APPLICATION NO.	FILING DATE	FIRST NAMED INVENTOR	ATTORNEY DOCKET NO.	CONFIRMATION NO.
10/803,779	03/18/2004	Hirofumi Harada	S004-5242	8062

Office Action Summary

DETAILED ACTION

FIG. 2 (PRIOR ART)

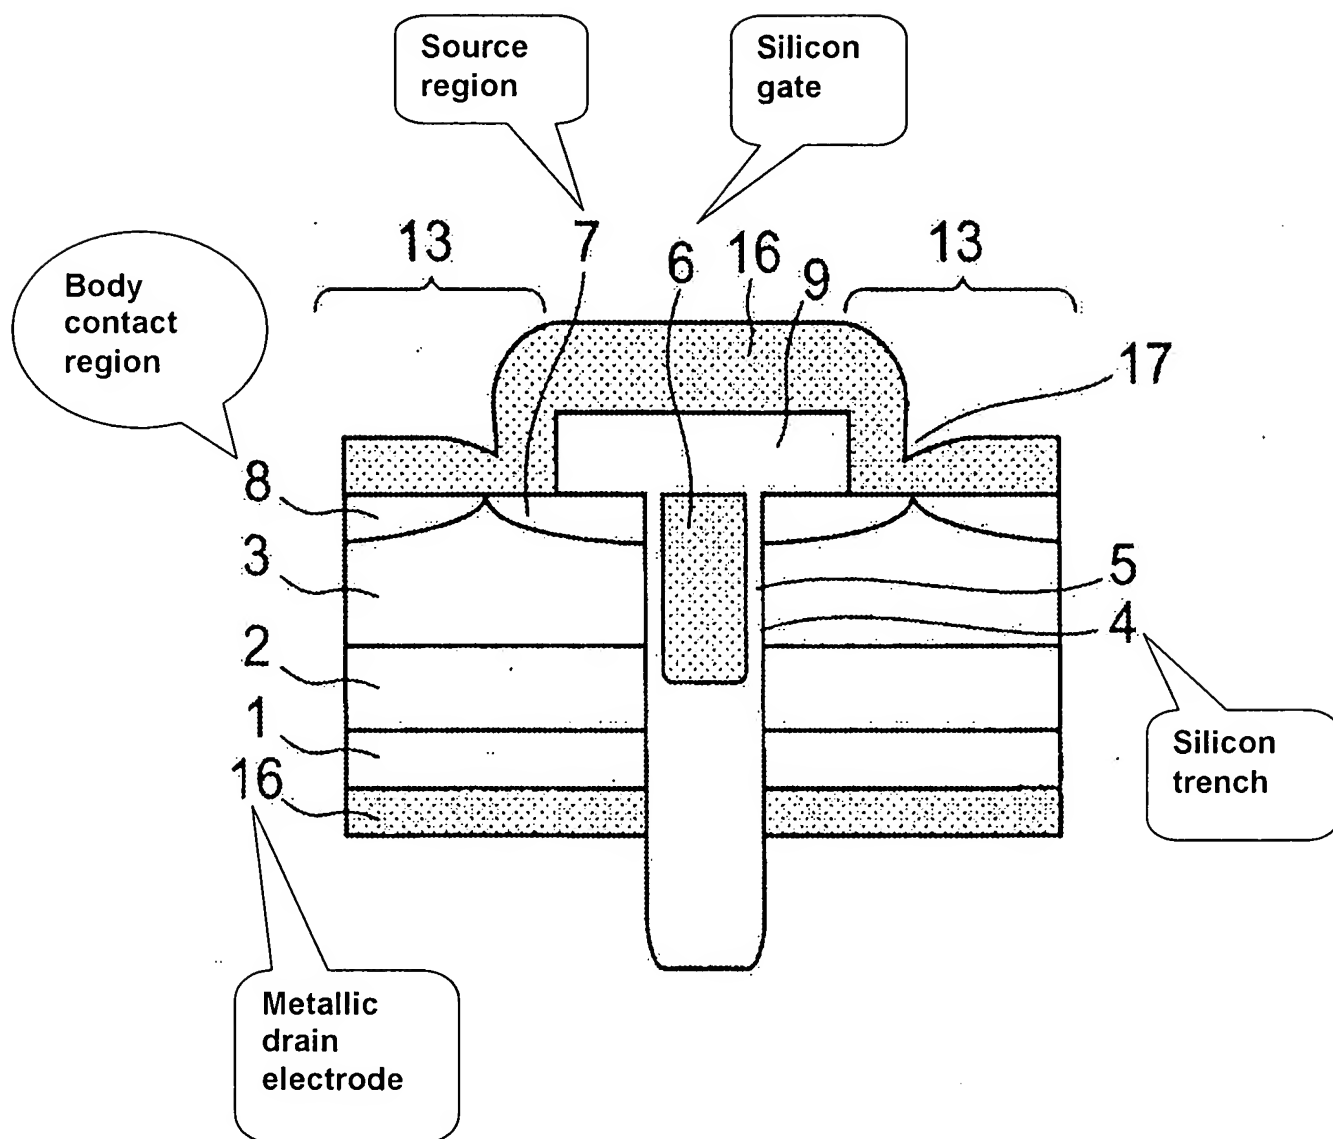
1. Figure 2 should be designated by a legend such as **--Prior Art--** because only that which is old is illustrated. See MPEP § 608.02(g). Corrected drawings in compliance with 37 CFR 1.121(d) are required in reply to the Office action to avoid abandonment of the application. The replacement sheet(s) should be labeled "Replacement Sheet" in the page header (as per 37 CFR 1.84(c)) so as not to obstruct any portion of the drawing figures. If the changes are not accepted by the examiner, the applicant will be notified and informed of any required corrective action in the next Office action. The objection to the drawings will not be held in abeyance.

Regarding claim 1, APA (Fig. 2) discloses a vertical MOS transistor comprising: a semiconductor substrate 1 of a first conductivity type (see Specification, page 1, lines 10-11); an epitaxial growth layer 2 of the first conductivity type which is formed on the semiconductor substrate 1 (see Specification, page 1, lines 8-11); a body region 3 of a second conductivity type which is formed on the epitaxial growth layer 2 (see

Specification, page 1, lines 14-17); a heavily doped body contact region 8 of the second conductivity type which is formed on a part of a surface of the second conductivity type body region 3 (see Specification, page 1, lines 18-21); a heavily doped source region 7 of the first conductivity type (see Specification, page 1, lines 18-20), which is formed on a part of the surface of the second conductivity type body region that is covered with the heavily doped body contact region 8 (see Fig. 2 labeled by the examiner below); a silicon trench 4 piercing the second conductivity type body region 3 and the first conductivity type source region 7 to reach an inner part of the first conductivity type epitaxial growth layer 2 (Specification, page 2, lines 6-8); a gate insulating film 5 formed along walls and bottom of the silicon trench 4 (Specification, page 2, line 8); a heavily doped polycrystalline silicon gate 6 buried in the silicon trench 4 while surrounded by the gate insulating film 5 (Specification, page 2, lines 8-10); an intermediate insulating film 9 formed on the polycrystalline silicon gate 6 in the silicon trench 4 to reach a surface the semiconductor substrate 1; a metallic source electrode 16 being in contact with the intermediate insulating film 9, the heavily doped source region 7, and the heavily doped body contact region 8; and a metallic drain electrode 16 connected to a rear surface of the semiconductor substrate 1 (see Fig. 2 labeled by the examiner below).

APA does not disclose a heavily doped polycrystalline silicon gate 6 buried in the silicon trench 4 to a level of the first conductivity type source region 7.
